Family Certification Attestation Letter

FCC : A3LEPQQ503

IC: 649E-EPQQ503

HVINs/Models: EP-QQ503, EP-QQ505, EP-QQ506, EP-QQ507, EP-QQ508,  
EP-QQ509, EP-QQ500, EP-QQ501, EP-QQ502

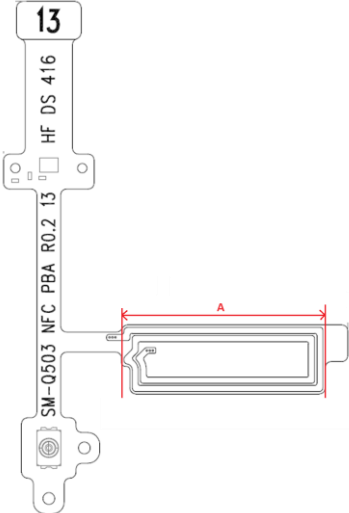
HVINs/Models	Loop PCB Antenna Length A
	EP-QQ505	14.6 mm
	EP-QQ506	15.1 mm
	EP-QQ507	
	EP-QQ508	15.8 mm
	EP-QQ509	
	EP-QQ500	16.6 mm
	EP-QQ501	
	EP-QQ502	17.2 mm
	EP-QQ503

Except for the loop PCB antenna length, the circuit and components/placement are the same. Models with different antenna lengths were tested and verified, and it was confirmed that they had similar characteristics and conformed to the standard.
